Re: Comments on Five-Year Evaluation of 180/400-Foot Aquifer Groundwater Sustainability Plan
prepared by Salinas Valley Basin Groundwater Sustainability Agency

To: Nancy Isakson, Salinas Valley Water Coalition
CC: Eric Robinson, Kronick Moskovitz Tiedemann & Girard
From: Dwight L. Smith, PG, CHg, Principal Hydrogeologist
Date: April 11, 2025
Subject: **Comments on the Five Year Evaluation of the 180/400-Foot Aquifer Subbasin Groundwater Sustainability Plan**

(HBA Update Figure ES-3.) The preceding maps show a 2- to 50-foot increase in groundwater elevation for the 180/400 and Eastside subbasins as a result of MCWRA project operations, with a smaller and more dispersed water level benefit in the Upper Valley and Forebay subbasins.

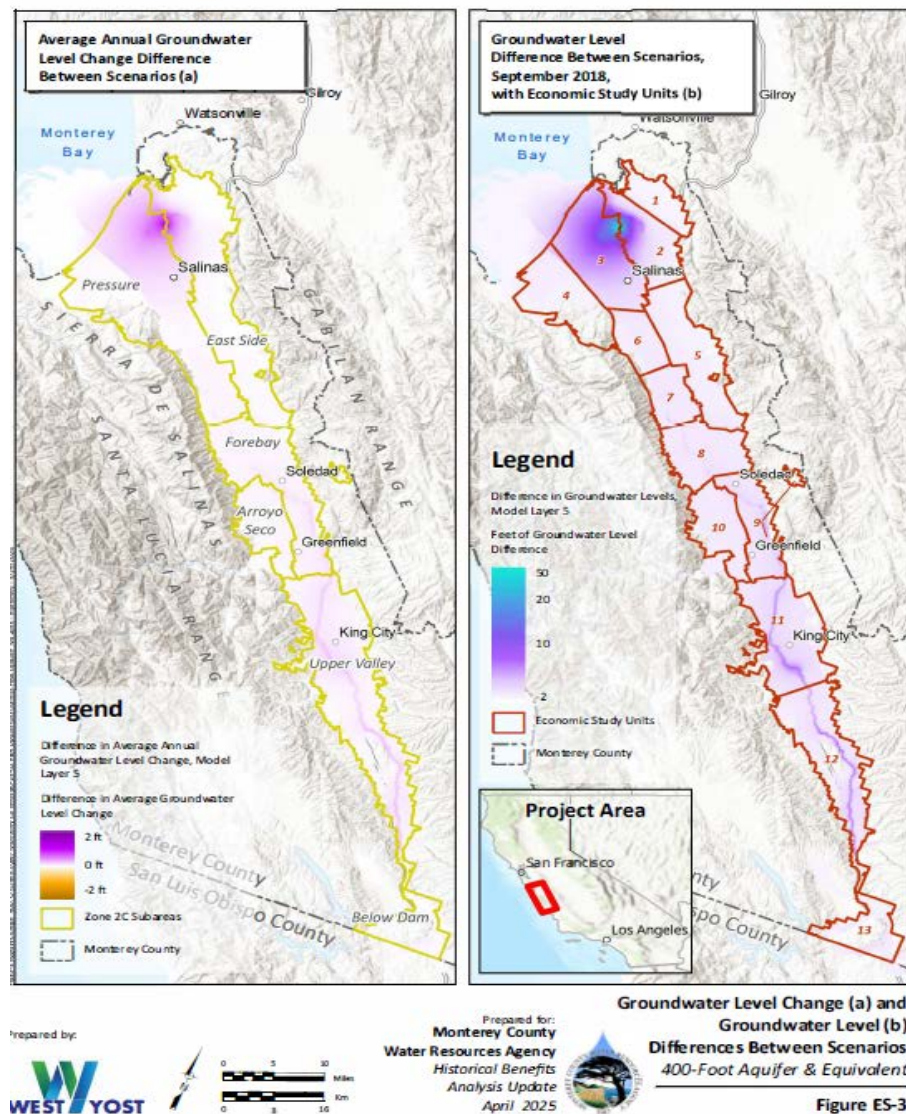
The 2025 HBA Update shows that MCWRA's existing water projects provide very significant recharge/water level benefits to the 180/400 and Eastside subbasins. The following “heat” maps show particularly significant benefits to those subbasins:
